**Re: Revised Traffic and Parking Assessment
3 Clyde Street, Batemans Bay**

The purpose of this letter is to provide additional information in response to traffic and parking issues raised in submissions to the Department of Planning collected during the exhibition of the proposal. Submissions were received from the NSW Roads and Traffic Authority, Eurobodalla Council and a member of the public.

CLYDE RIVER MOTOR INN

Figure 1

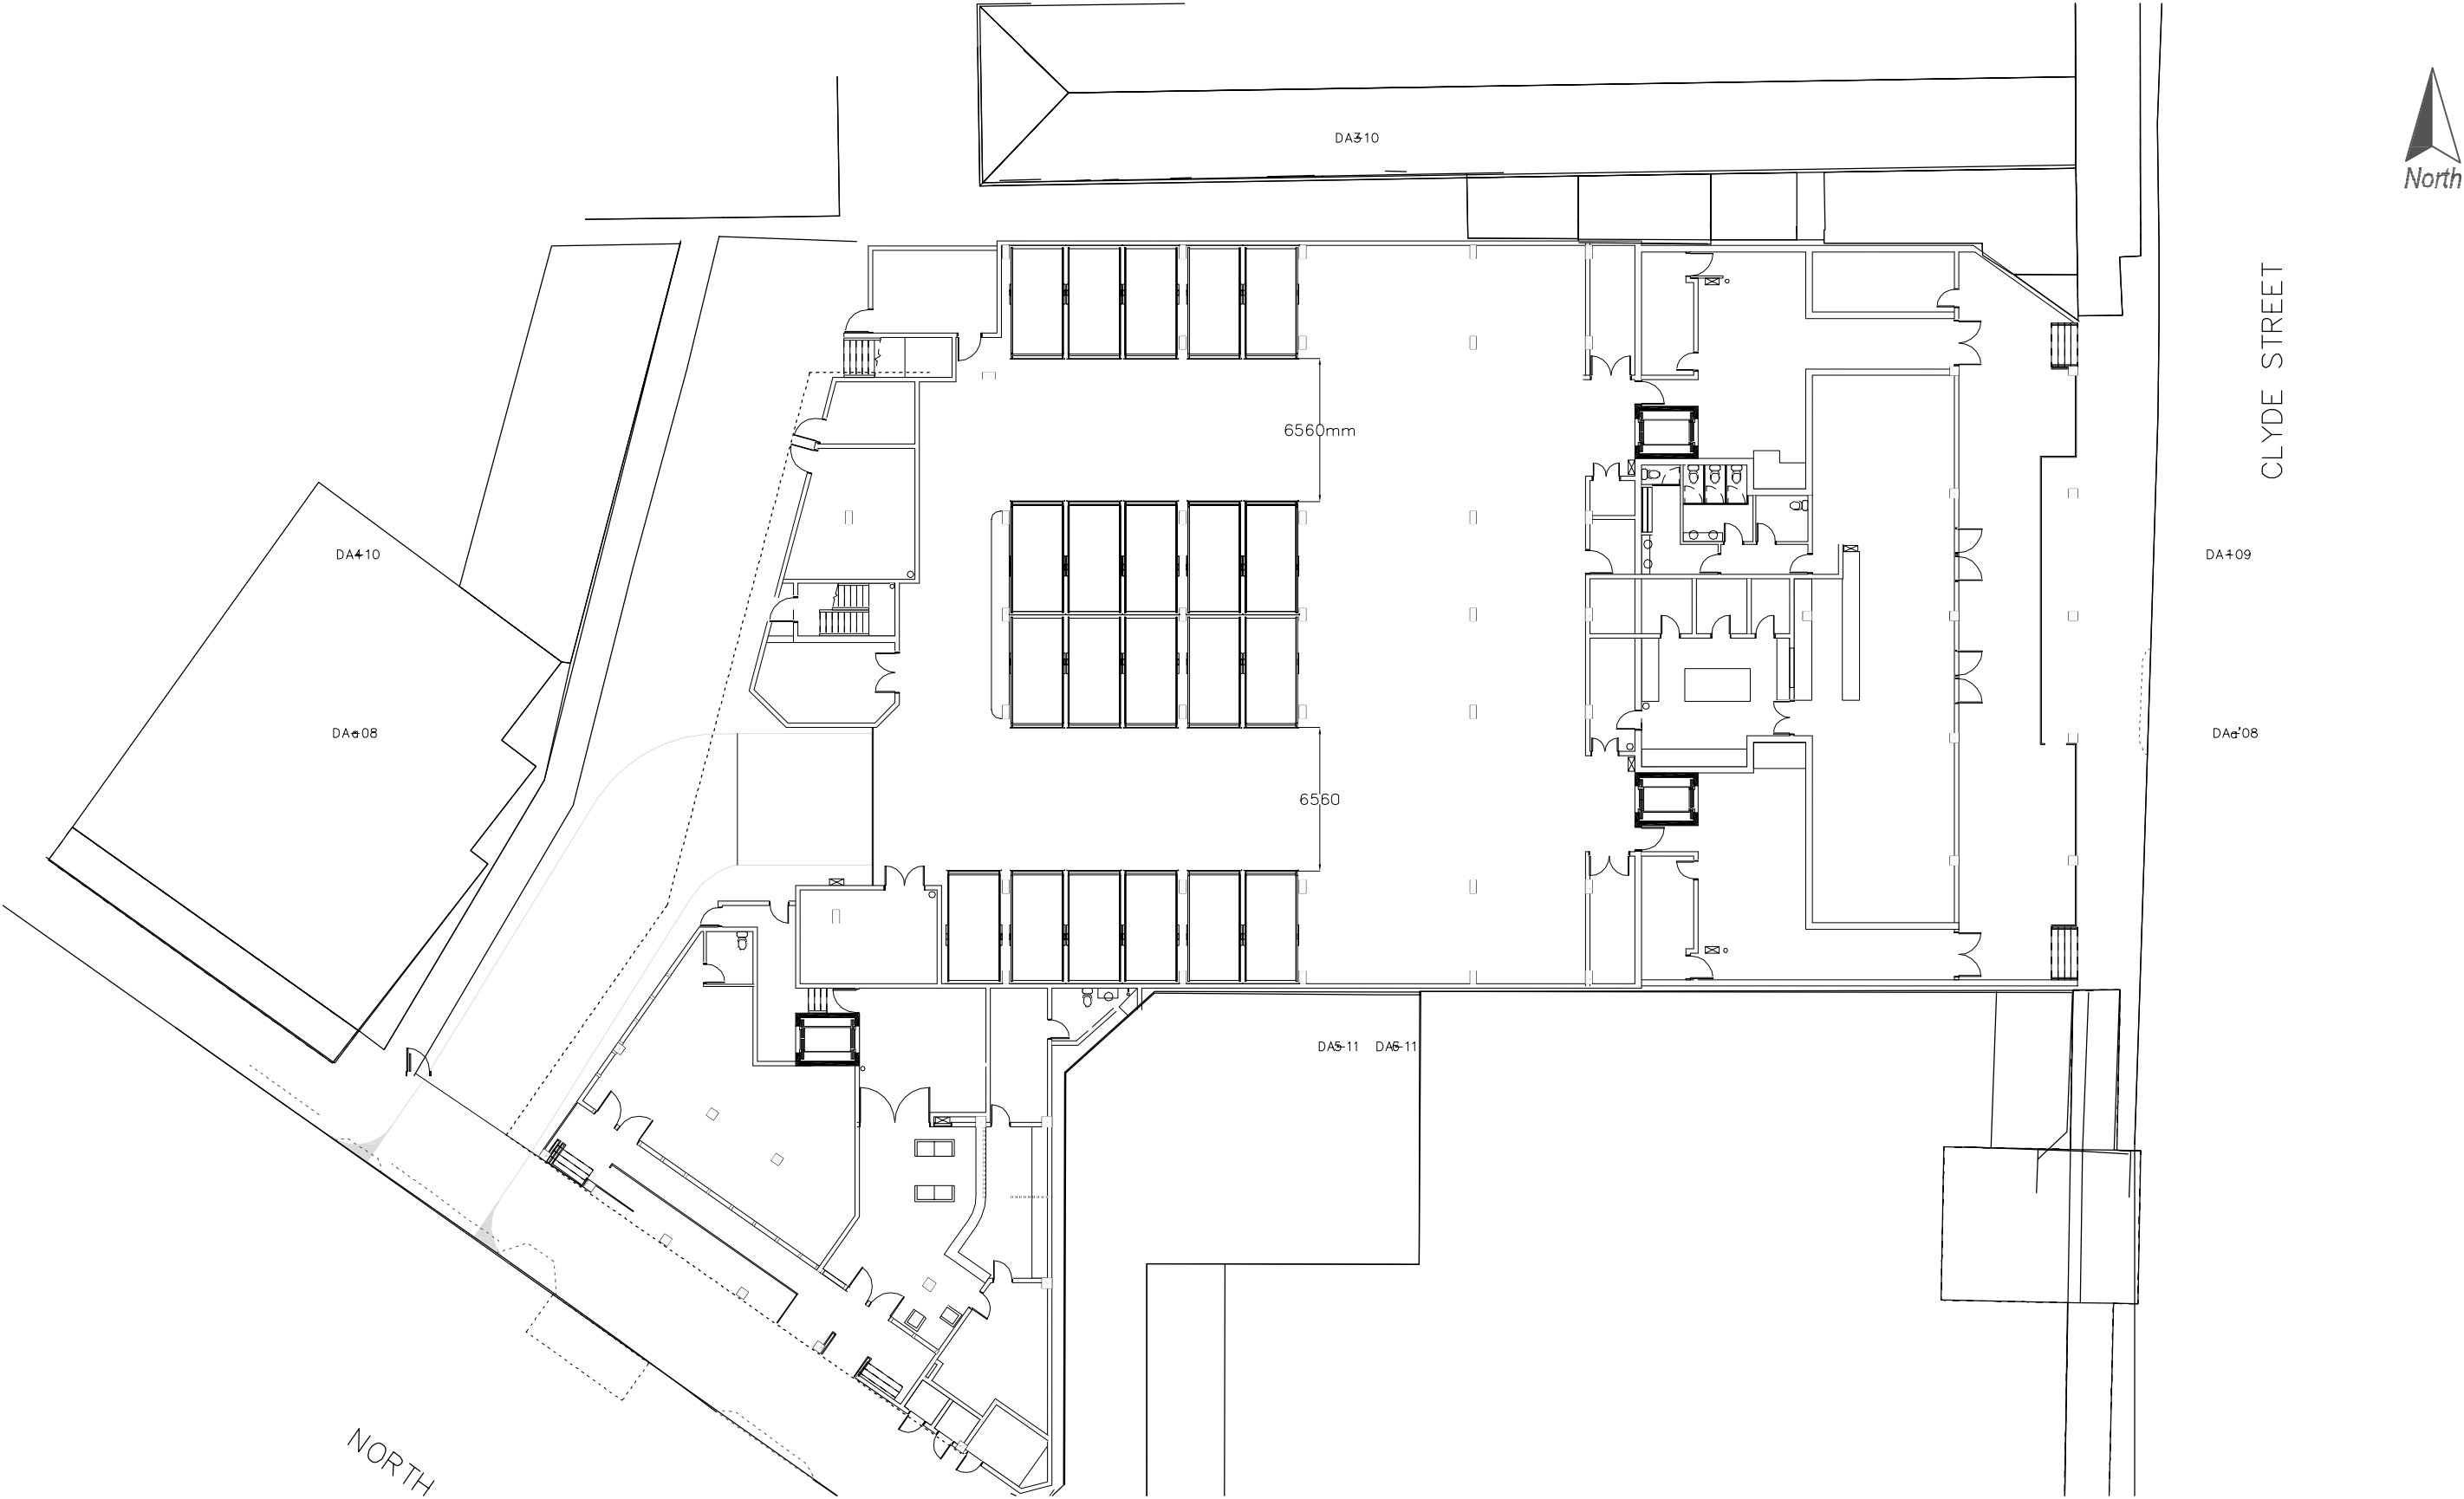
"Please clarify the 'required aisle width' for the car stacker of 6.95m, versus the effective aisle widths of 5.9m and 6m."

The proposed car stacking system for the development is the Klaus Single Vario 2061. A copy of the technical specifications of this car stacker is provided in **Appendix B** of this report. A plan showing the proposed car stackers within the car park is provided in **Figure 1** of this report.

The system includes a 5.2m long, 2.3m wide tray which accommodates one vehicle per tray. Each tray is supported on either side by thin columns. To ensure a vehicle does not travel over the outside edges of the tray, the tray is formed with 200mm high upturns on each side. These upturns extend for the full length of the tray. The clear width of each tray between upturns is 2.3m and the clear width of the at-grade space between the support columns is 2.4m.

Once a vehicle has parked on the tray, the tray is elevated to then allow another car to park underneath. The car stacker allows vehicles up to 1.8m in height to park on ground and up to 1.5m in height to park on the tray.

The available aisle width between car stacker trays on either side of each aisle was measured to be 6.50m. This is also shown in **Figure 1**. Assuming the at-grade space is 5.4m long, the effective aisle width of at-grade spaces would be 6.10m.

The parking space dimensions and adjacent aisle widths for the at-grade and tray parking spaces within the car stackers are summarised below:

Parking Space	Length	Width	Effective Adjacent Aisle Width
At Grade	5.4m	2.4m	6.10m
Trays	5.2m	2.3m	6.50m

For long stay (residential, domestic, employee) parking, the Australian Standard recommends 2.4m wide, 5.4m long spaces with a minimum adjacent aisle width of 5.8m. The at grade car space dimensions and adjacent aisle width comply with the standard and are therefore considered satisfactory.

Figure 2

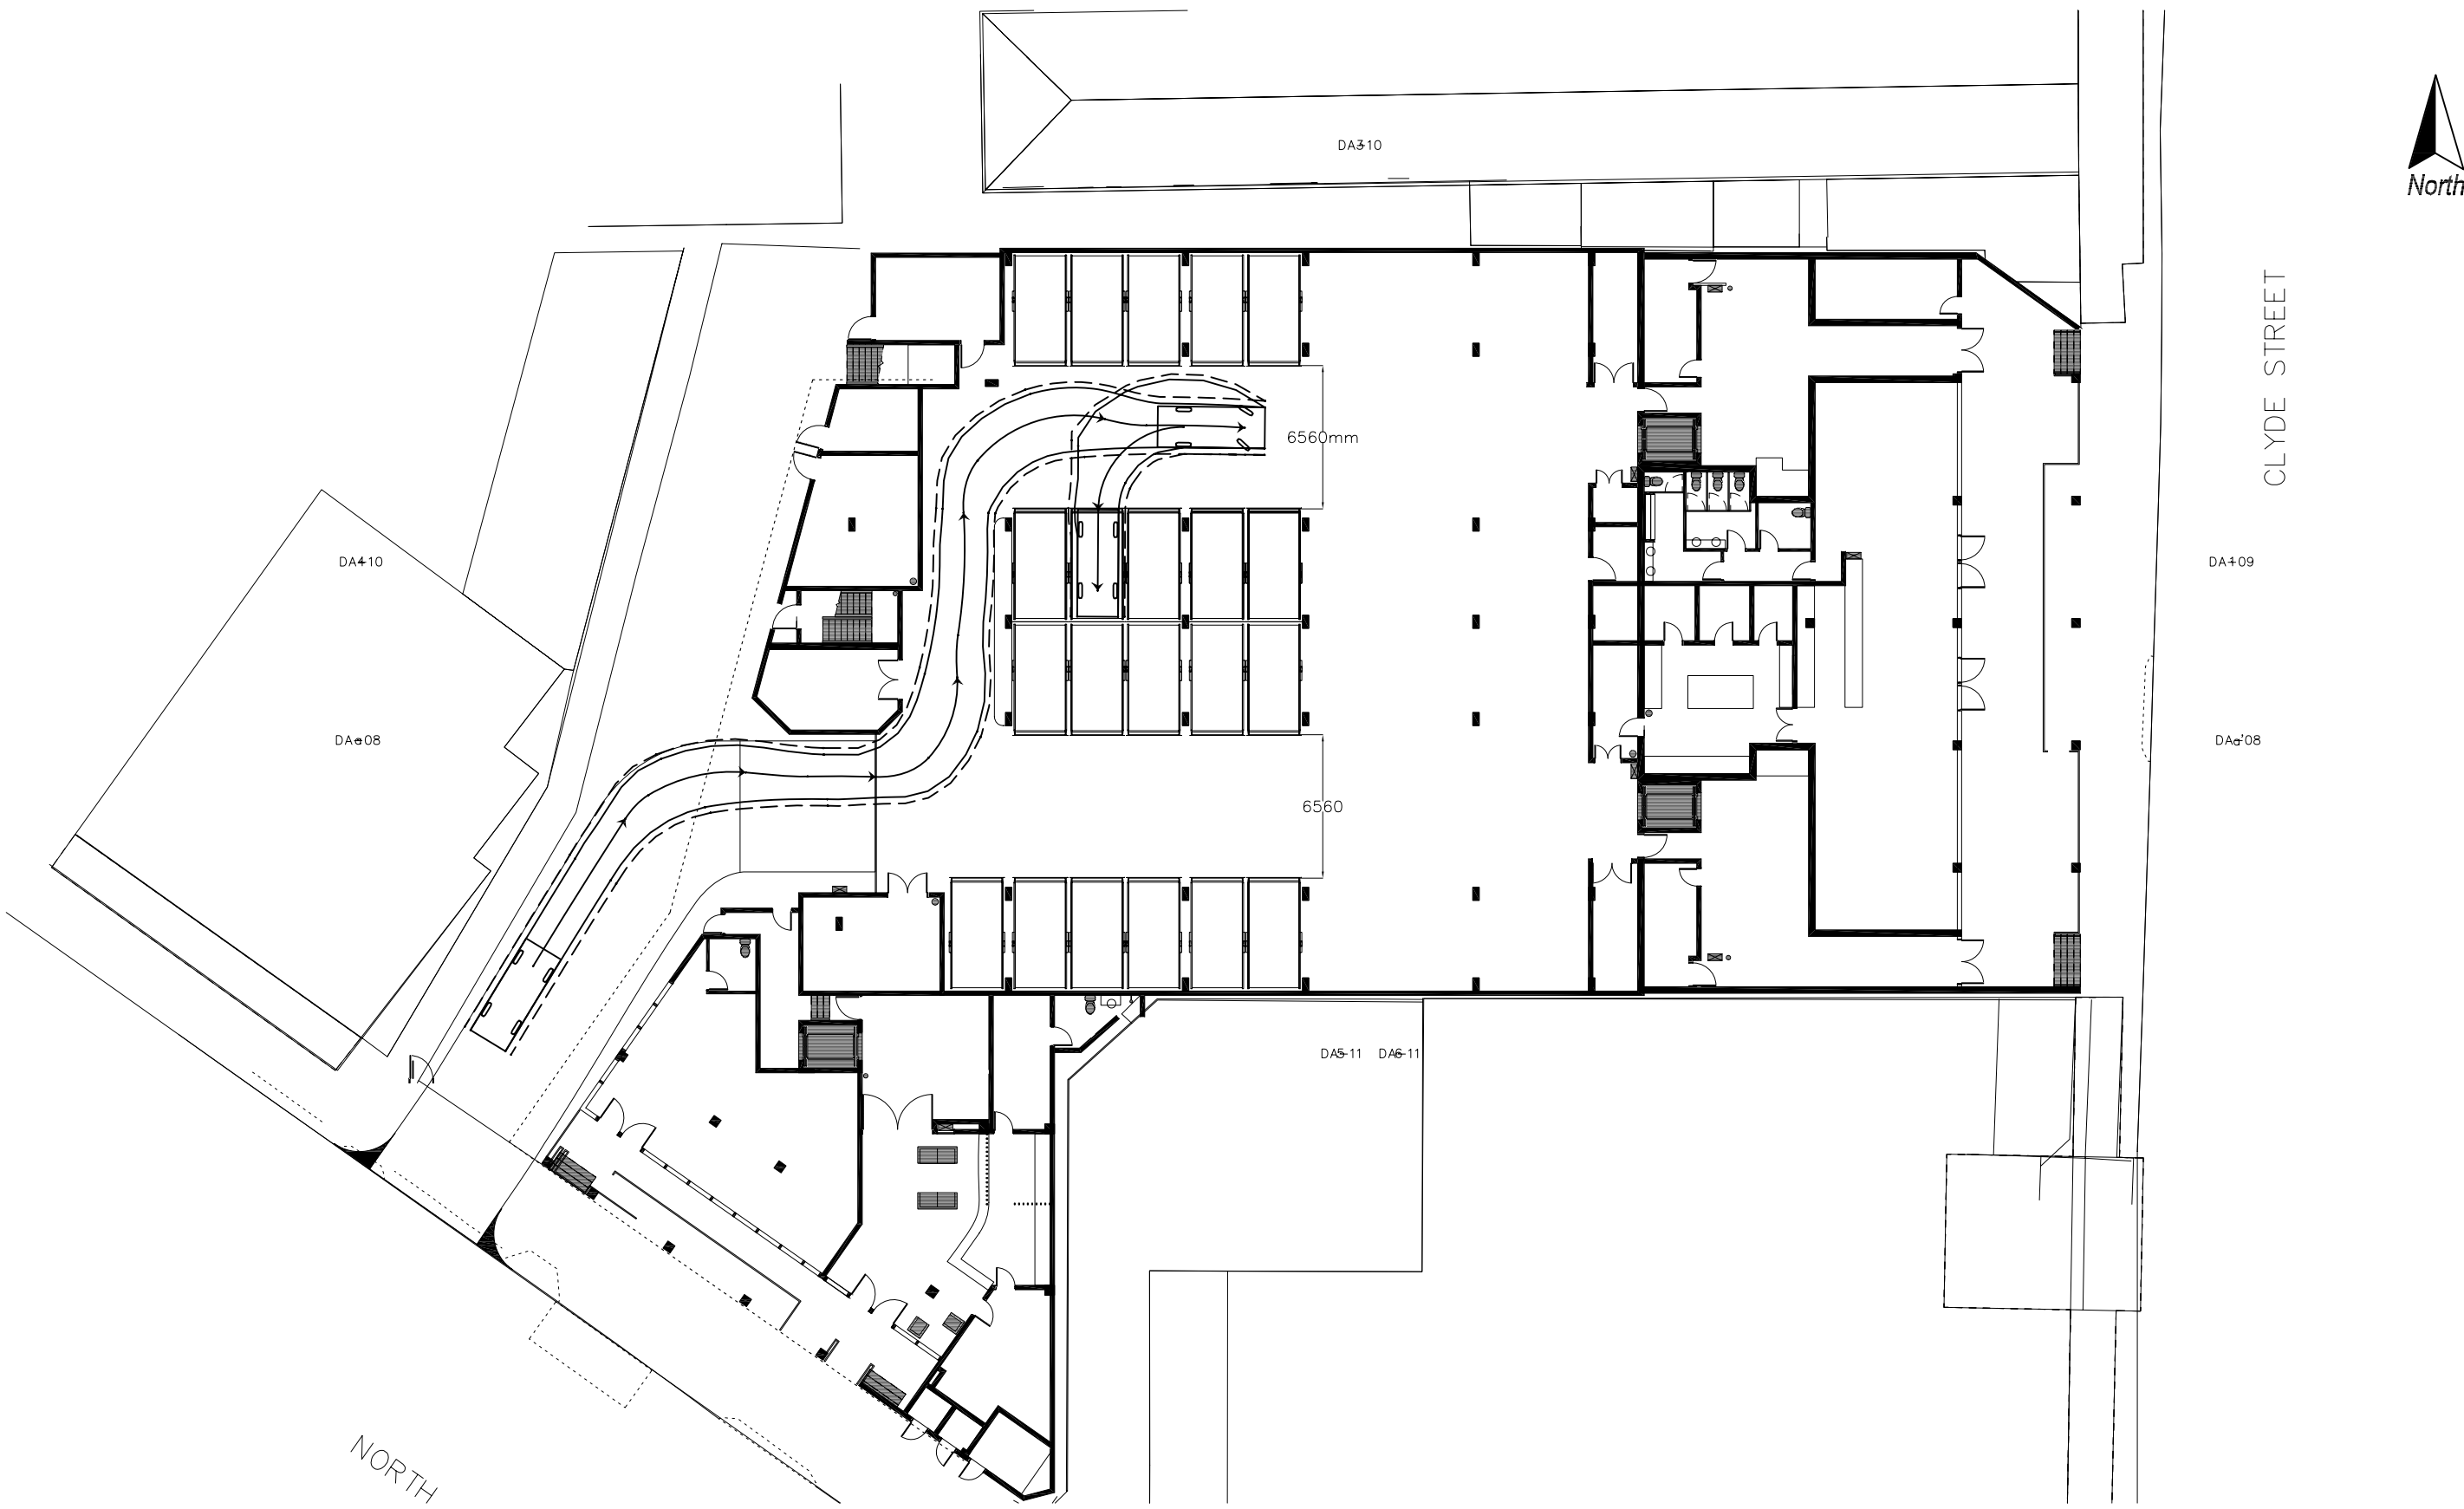
As stated in our traffic report, an issue with the proposed car stacker is the upturns on the sides of the trays (platforms) which restrict the angle at which a vehicle can enter them. The effect of the tray upturns is to deny vehicles the opportunity of turning across the adjacent space, meaning that a wider aisle width is necessary to allow a vehicle to access the space at an angle of close to 90 degrees.

The Australian Standard for Off Street Parking Facilities – AS2890.1, suggests that small car spaces can be provided at a width of 2.3m and a length of 5.0m. Therefore as a minimum the trays of the car stacker could be considered ‘small car’ spaces. The standard specifies the following design vehicle characteristics.

We have tested an 85th percentile vehicle reversing into a car stacker tray using the AutoTURN vehicle swept path computer program. This turning path is shown in **Figure 2** attached. From **Figure 2** it can be seen that an 85th percentile vehicle could reverse into the car space tray and thus the stacker trays could be used for vehicles up to this size as well the 85th percentile vehicle is equivalent to a large family sedan such as a Ford Falcon or Holden Commodore.
